# Health and Safety Inspection Report

Northumberland County Council

## Hexham Bus Station

#### Health and Safety Inspection

**Photograph 1** - This shows the dedicated pedestrian route blocked by displayed produce and a designated path within the Highway.

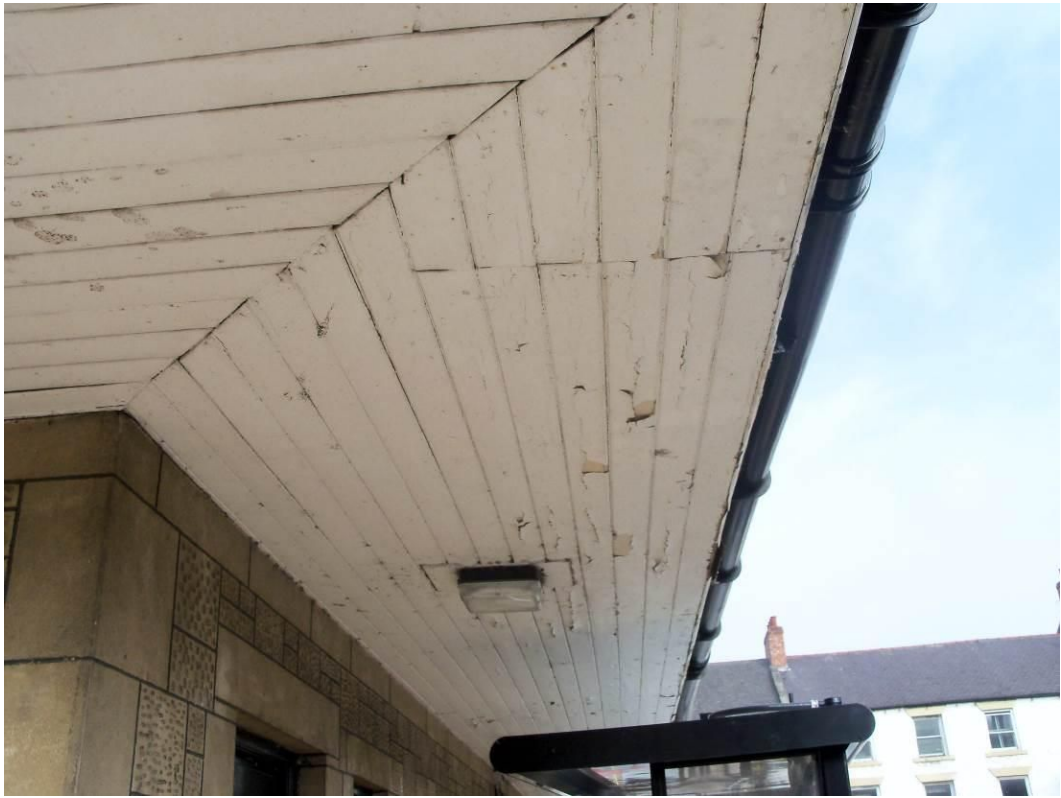
2.1 The means of separating vehicle and pedestrian routes within the station leaves much to be desired. The ownership of Commercial Place is not clear and many disputes have arisen in the past regarding access rights. The painted pathway on the road along Commercial Place is also often used as a delivery bay. This problem is exacerbated by the fact that the owners of the vegetable shop often display produce on sale along the existing path. Despite the lack of proper separation, drivers seem to take care when entering the station and no accidents or near misses have been reported. Ideally, this path should be widened and kept clear of goods, removing any need for pedestrians to walk on the road.
